Sedan Range

14-06

TECHNICAL BULLETIN

Cooling System Fan Fuse Failure – Single Pressure Switch – Service Modification

ILLUSTRATION 1

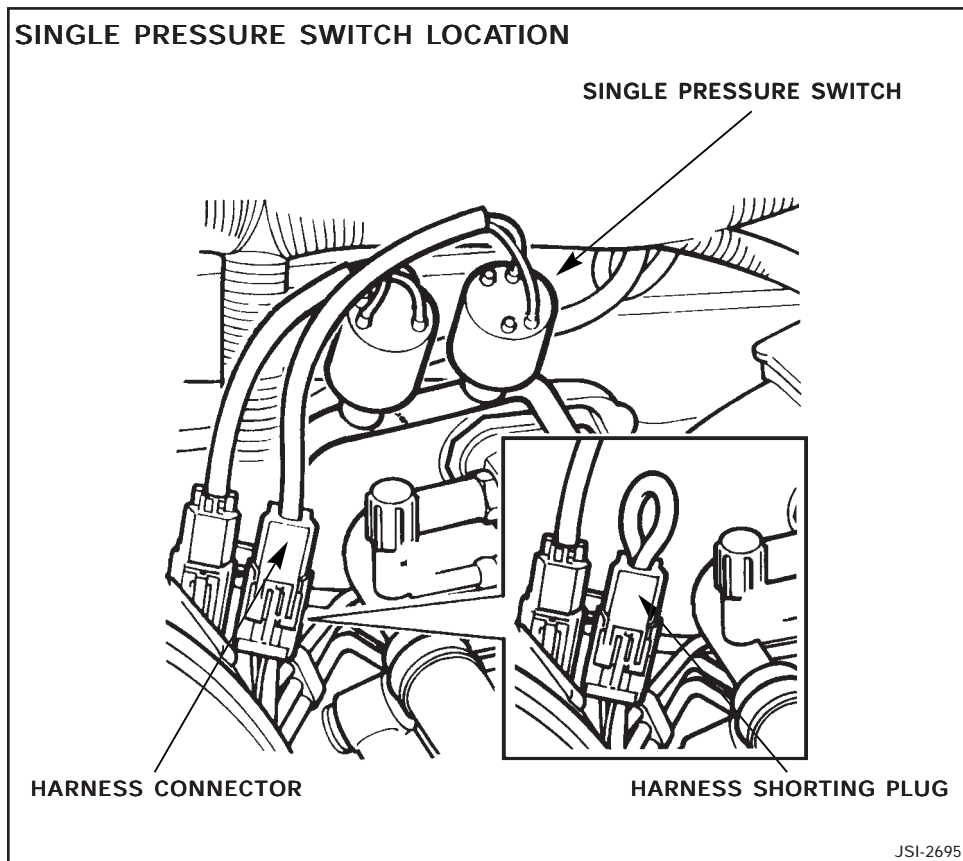
Following investigations into this concern and reappraisal of vehicle operating conditions, the single pressure switch has been deleted from the vehicle specification starting with VIN 761570. The switch has been replaced by a shorting plug. The cooling fans will now operate continuously at slow speed when the ignition switch is in position II (normal engine running position). This means the 86°C contacts on the radiator thermostatic switch are now redundant. High speed mode is still controlled by the refrigerant triple pressure switch and the radiator thermostatic switch as before. Refer to Fig. 7.1 of the Sedan Range 1995 Electrical Guide.

If the cooling fan relay module has failed in either a short circuit or open circuit mode, the cooling fan circuit **must** be modified as described on the next page in addition to replacing the relay module. The modification is necessary because of the known failure mode of the pressure switch, which may cause sticking of the relay contacts and/or may switch the fans into a parallel circuit condition (high speed mode), causing the fan fuses to blow.

1. Identify the single pressure switch (Illustration 1) and disconnect the harness connector.
2. Unscrew and remove the single pressure switch from the Schrader valve connection (Illustration 1) on the refrigeration line.

3. Install and tighten the dust cap provided in the modification kit on the exposed Schrader valve connection.
4. Remove the harness connector from its mounting bracket.
5. Insert the shorting plug supplied in the modification kit into the harness connector. Insert the harness connector into its bracket.
6. Turn the ignition switch to position II and check that the cooling fans run at the slow speed.
